Memorandum

To: Planning Board Members
From: Bonnie Flynn, AICP/PP, CFM, Dir. of Planning & Com. Dev.
Ron Yake, AICP/PP, Township Planner & Zoning Officer
Date: February 8, 2024
Re: **Princeton Nurseries Concept Plan - WRV Nurseries, LLC**

Concept Plan Review

Application: P22-09

Above: Land Use Areas concept applied to WRV Concept Plan (December 2023)

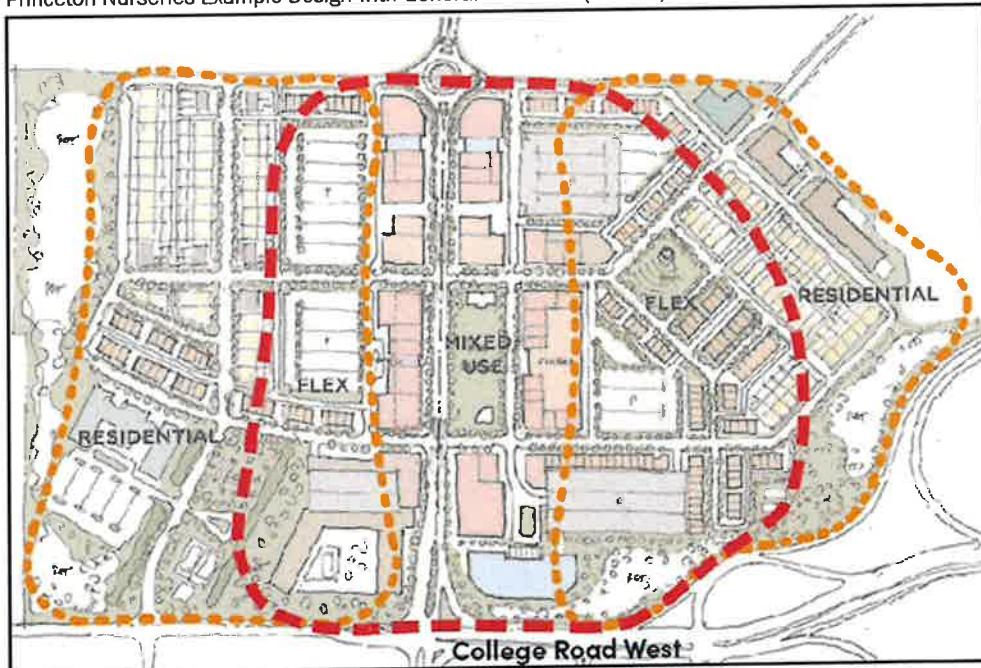
The GDP requires three land use areas within the development site; two Residential Areas one adjacent to the eastern and one adjacent to the western boundaries of the site, one Mixed-Use Area centrally located within the site, and two Flex Areas located between the Mixed-Use Area and each Residential Area. According to the GDP, the Flex Areas are defined as areas within the site that permit all uses in Mixed-Use Area except for single-family detached units and are intended to provide a transition from Mixed-Use Area to the Residential Areas in terms of building mass, height, density, and land uses. The applicant shall explain how the requirement to include these five areas is satisfied by the proposed concept plan.

To address the question of how the requirement to include five different land use areas is satisfied in the concept plan, WRV would offer the following:

- As a reminder, the three Land Use Areas (Residential, Mixed-Use, and Flex) are described in the GDP as a framework for “sensitively and respectfully integrating the development with existing land uses and infrastructure in the vicinity of the Nurseries site” and requires each Land Use Area to be differentiated by its location, allowable uses, and physical form with the goal being to center the most intensive, high-density uses within the Mixed-Use Area along the central pedestrianized core.

- The WRV concept plan proposes organizing the Land Use Areas in a manner that is very similar to illustrative examples included in the GDP (see below); that is, a north-south linear Main Street with high-density residential uses, flanked by a Flex Area transition zone of parking and landscaping, stacked flats, and higher-density townhomes, ultimately leading to the Residential Areas at the site's periphery.

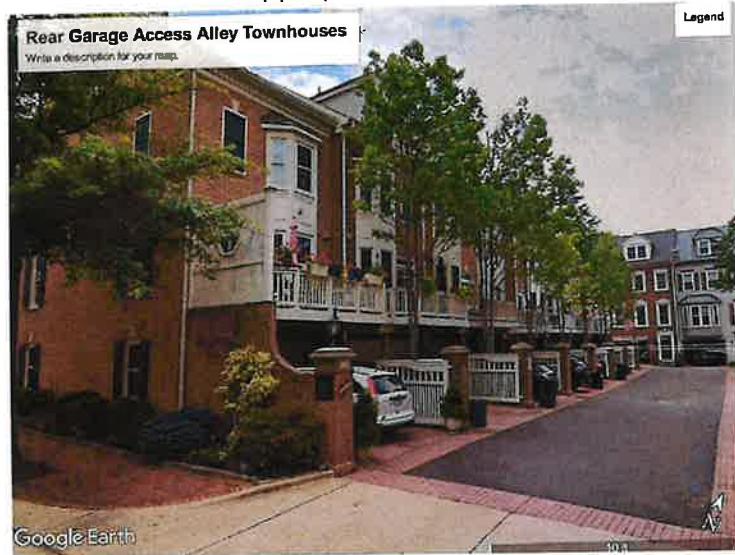
- a. Staff has been concerned with the lack of pedestrian accommodations throughout the east and west residential areas of the concept plan, especially within the various townhouse units garage access alleys. In the latest concept plan that the Development Review Committee members will receive, the applicant has made progress towards improving pedestrian accommodations in the aforementioned alleys, noting that all such alleys will include paver/stamped concrete pedestrian paths. On page 28 of Exhibit A of the applicant's concept plans, entitled "Potential Pedestrian/Bicycle Linkages," Staff has identified one alley in the east side townhouse area and six alleys in the west side townhouse area where additional pedestrian accommodations need to be shown (see below). The applicant should include such information in plans that go onto the Planning Board for consideration.

Thank you for pointing out these oversights. Please see the updated attached Exhibit A that includes these linkages where they were missed.

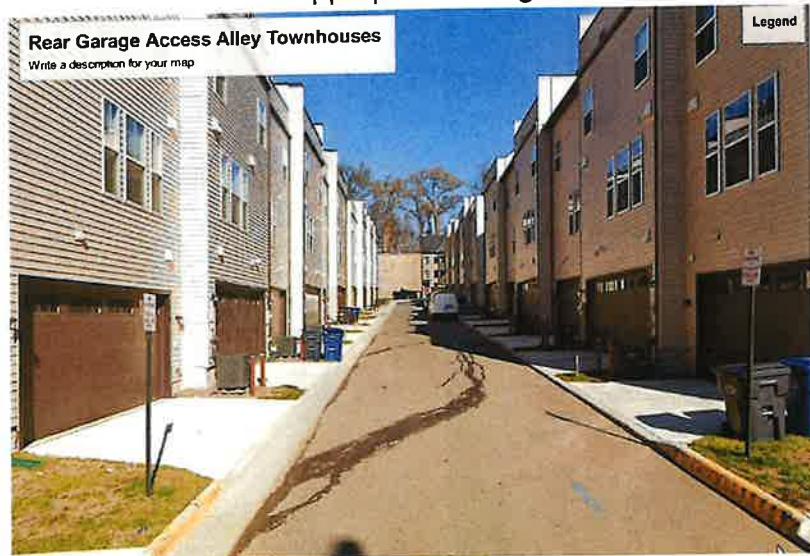
- b. In addition to the issue of pedestrian accommodations in such alleys, Staff is also concerned about the potential appearance of such alleys, which may lack landscape/hardscape, fencing, and elevated deck improvements along the rear of the townhouse units that would contribute to creating a high-quality visual environment as seen from both inside and outside such alleys. Staff believes these alleys can be both functional from a vehicular access standpoint, as well as attractive and "pedestrian-friendly." See examples below of appropriate and inappropriate design.

The partners of WRV have experience building rear access townhomes across the state and as we have discussed with staff previously, all townhomes will have decks, architectural articulation, and appropriately modest landscaping on the rear elevations. We are also comfortable creating fenced separations between driveways in allies, and we will illustrate all of these design features at the time of site plan submittal when the elevations and architecture for the townhomes are further developed.
